| Model: Stella-F1 | | Date: 13-Feb-02 | No.: MH555001 |
| Modified Article: Parts Catalog Correction | | Prepared by: A. Ishiyama | |
| From: Technical Services Dept., GTS Division | | | |

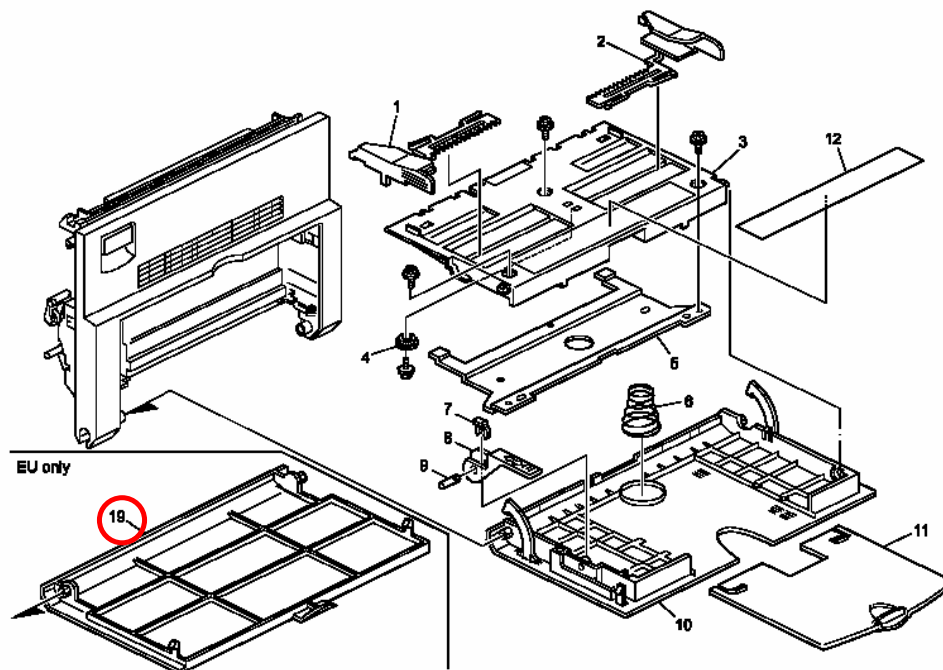
Please make the following corrections to your Parts Catalogs.

| Incorrect part number | Correct part number | Description | Q'ty | Int | Page | Index | Note |
|-----------------------|---------------------|---|------|-----|------|-------|------|
| | H5558609 | Operating Instructions - Basic: Asia (Ricoh) | 0→1 | | 47 | 8 | |
| | H5558709 | Operating Instructions – Advanced: Asia (Ricoh) | 0→1 | | 47 | 8 | |
| | H5558629 | Operating Instructions – Basic: Asia (Ges) | 0→1 | | 47 | 8 | |
| | H5558729 | Operating Instructions – Advanced: Asia (Ges) | 0→1 | | 47 | 8 | |

| Modified Article: Guide Plate Stopper | | Prepared by: M. Ishihara | |

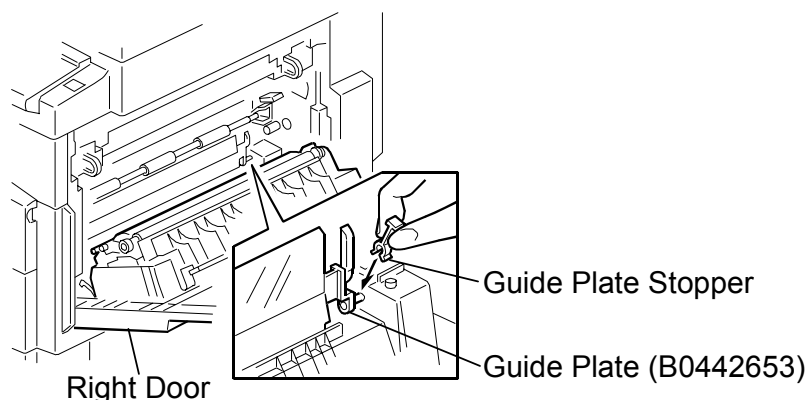
| Old part number | New part number | Description | Q'ty | Int | Page | Index | Note |
|-----------------|-----------------|---------------------|------|-----|------|-------|------|
| - | B0442656 | Guide Plate Stopper | 0-1 | | 9 | | New |

A Stopper has been added to the Guide Plate shaft to ensure the Guide Plate pivot point does not come out of place, which can occur when paper jammed in the transport section is removed from the paper tray side with the right door closed (normally, paper jammed here should be removed after opening the right door).

Machine cut-in serial number:

H555-17: A35291xxxxx-
 H555-22: A3529100701-
 H555-23: A35291xxxxx-
 H555-24: AL1152870001-
 H555-26: 4N78720001-
 H555-27: A3529100699-
 H555-29: A3529100801-

| Modified Article: Parts Catalog Correction | | Prepared by: A. Ishiyama | |

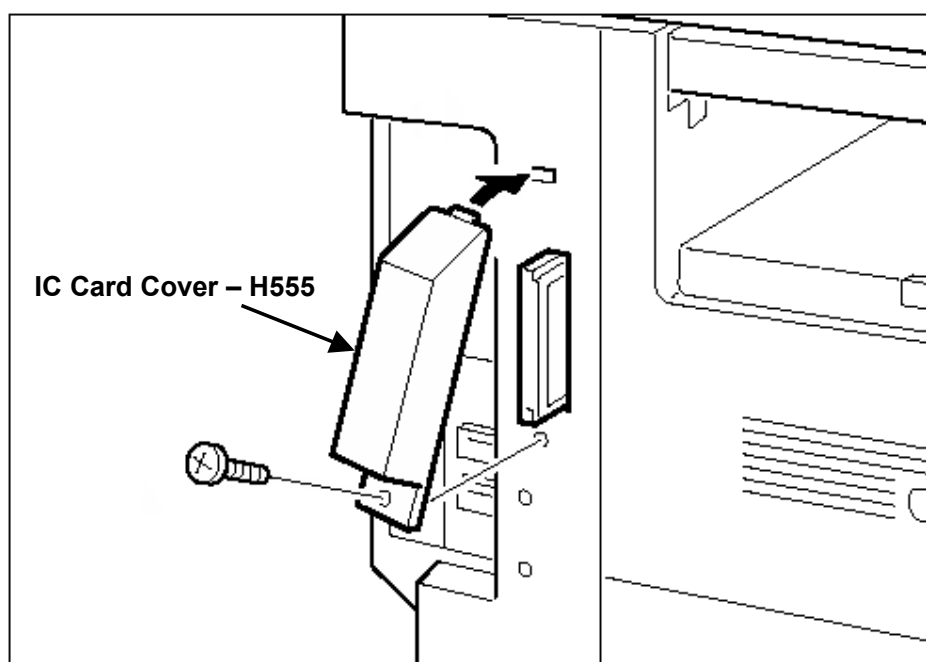
The following cover has been added to protect the IC Card slot.

| Incorrect part number | Correct part number | Description | Q'ty | Int | Page | Index | Note |
|-----------------------|---------------------|----------------------|------|-----|------|-------|------|
| | H5554250A | IC Card Cover – H555 | 0→1 | | 3 | 25 | |

| Modified Article: Stripper Pawls | | Prepared by: M. Ishihara | |

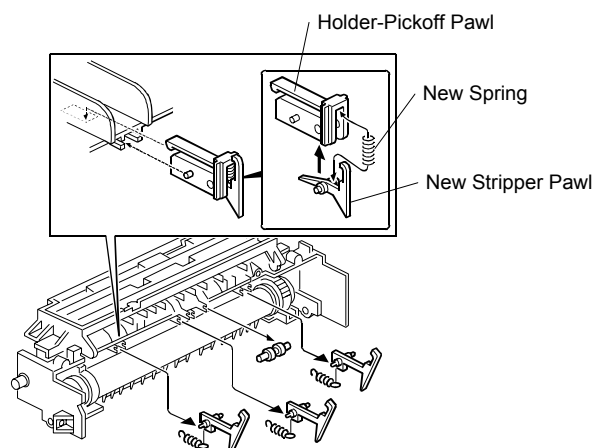
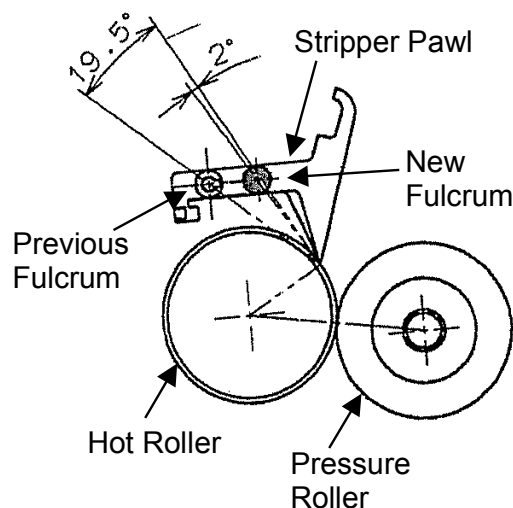
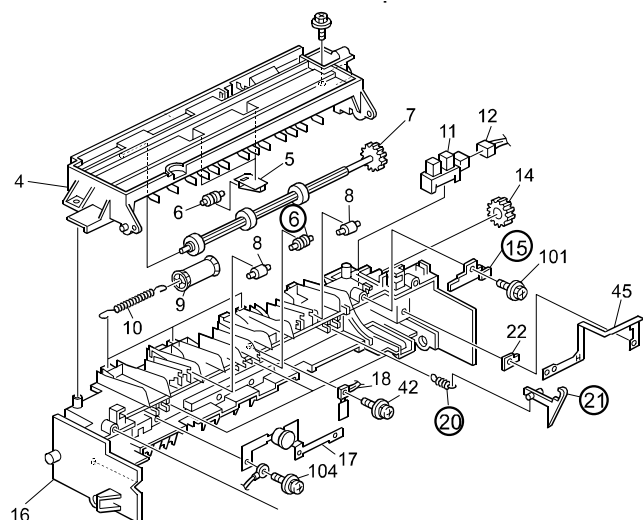
The fulcrum of the Stripper Pawls has been changed as shown below to eliminate squeaking noises coming from the pawls. In addition, pawl holders have been added for attachment to the pawls before installation in the fusing frame (frame remains unchanged).

| Old part number | New part number | Description | Q'ty | Int | Page | Index | Note |
|-----------------|-----------------|-----------------------|-------|------|------|-------|------|
| AE044036 | AE044045 | Stripper Pawl | 3 – 3 | X/O* | 25 | 21 | |
| AF022141 | | Turn Roller | 3 – 2 | | 25 | 6 | |
| B0444151 | B0444155 | Spring – Pickoff Pawl | 3 – 3 | X/O* | 25 | 20 | |
| | B0444179 | Holder – Pickoff Pawl | 0 – 3 | | 25 | New | |
| B0444144 | B0444143 | Electrode Plate Cover | 1 – 1 | X/O* | 25 | 15 | |

X/O*: **Interchangeability is X/O as a set.** In addition, whenever replacing the old with the new, be sure to install **all four** new parts above as a set.

| Modified Article: Connector-OR/P17-14S-B | | Prepared by: M. Ishihara | |

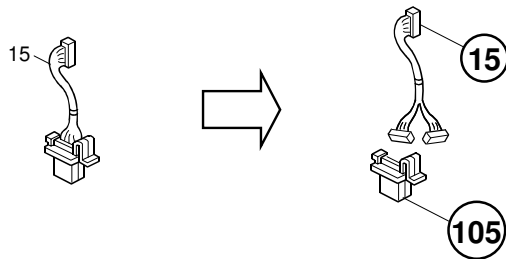
Please correct the parts catalog as follows.

| Part number | Description | Q'ty | Int | Page | Index | Note |
|-------------|------------------------------|------|-----|------|-------|------|
| B0445223 | Harness – Paper Feed Table | 1 | | 29 | 15 | |
| 11028534 | Connector – OR/P17 – 14S - B | 1 | | 29 | 105 | |

| Modified Article: ADF Base | | Prepared by: A. Ishiyama | |

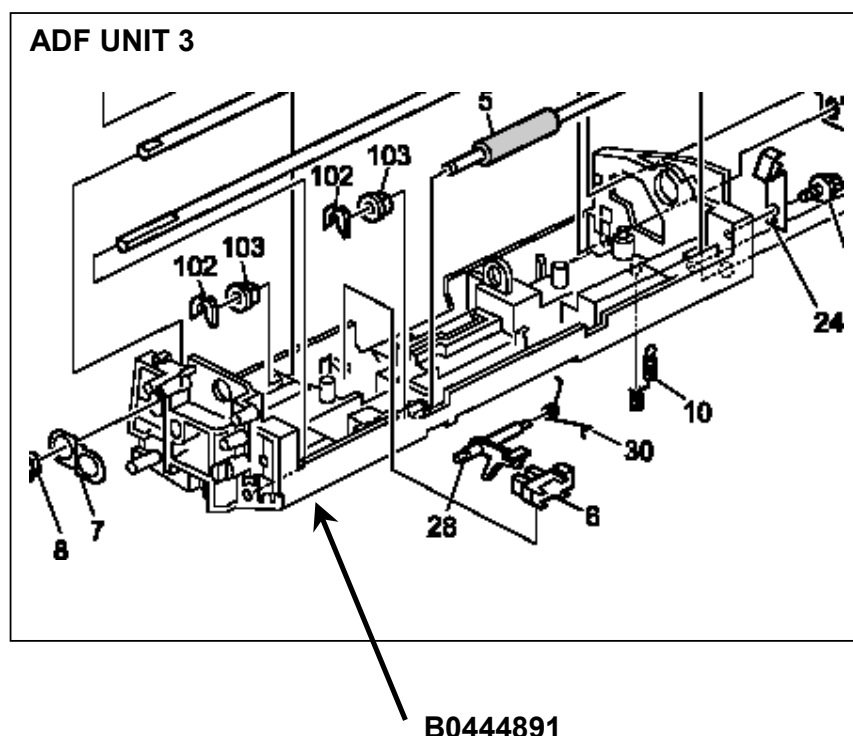
| Old part number | New part number | Description | Q'ty | Int | Page | Index | Note |
|-----------------|-----------------|-------------|------|-----|------|-------|------|
| | B0444891 | Base | 0→1 | -/- | 19 | 33 | |

Change: This part was added.

Reason: It was missing from the Parts Catalog.

13.DRIVE SECTION (H555)

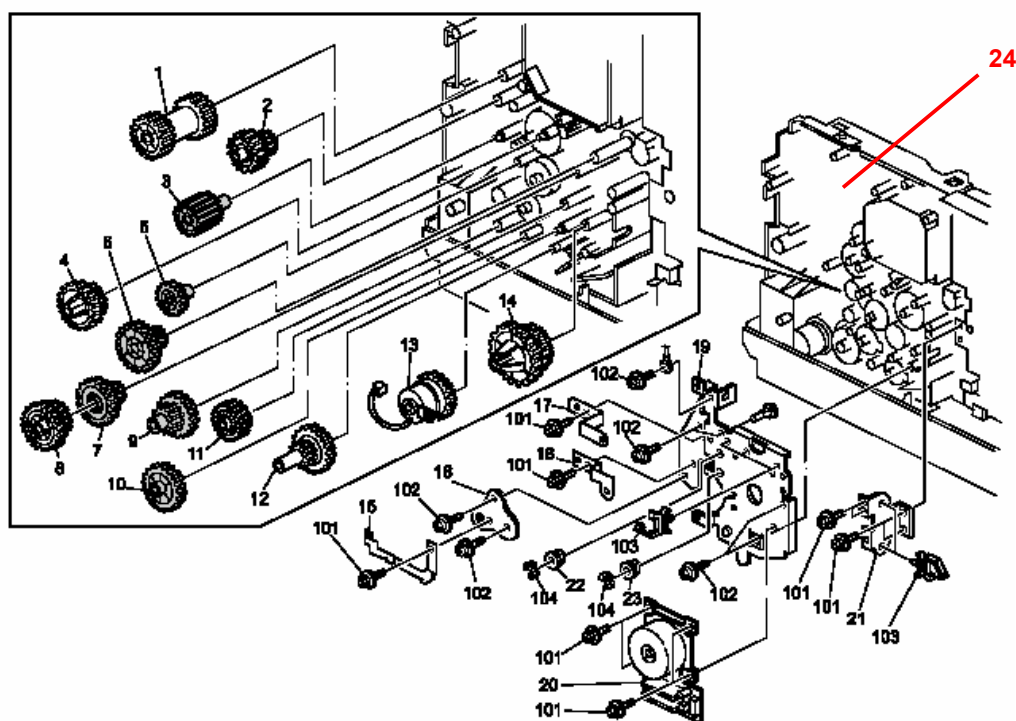
Please correct your Parts Catalogs as follows:

| New part number | Description | Q'ty | Page | Index | Note |
|-----------------|---------------|------|------|-------|------|
| B0441177 | FRAME - DRIVE | 1 | 27 | 24 | |

5.TRANSPORT SECTION (H555)

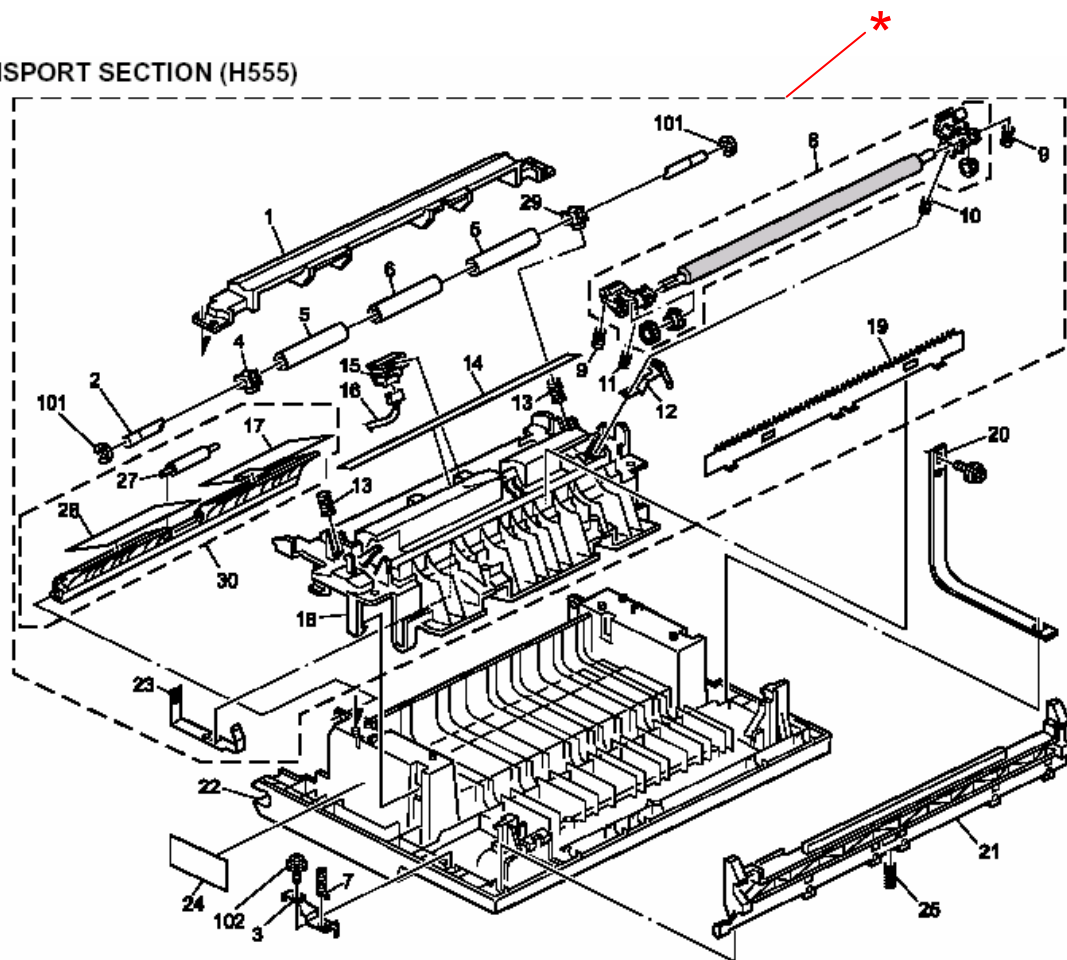
| New part number | Description | Q'ty | Int | Page | Index | Note |
|-----------------|---------------------------|------|-----|------|-------|------|
| B0444653 | GUIDE PLATE:REVERSE:ASS'Y | 1 | - | 10 | * | |

1.EXTERIOR (H555)

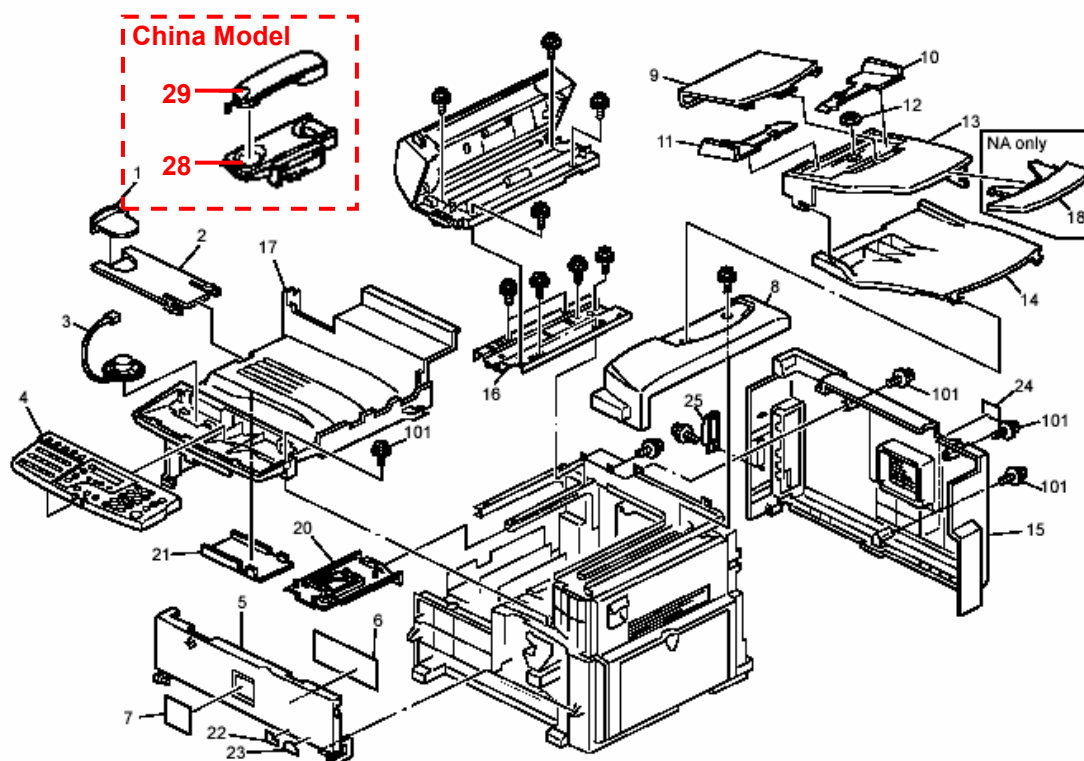
| New Part Number | Description | Q'ty | Page | Index | Note |
|-----------------|-------------------------------------|------|------|-------|------|
| H4534156 | Hand set – Holder (For China model) | 1 | 3 | 28 | - |
| H4535127 | Hand set (For China model) | 1 | 3 | 29 | - |

Change/Reason: These parts were missing from the Parts Catalog.
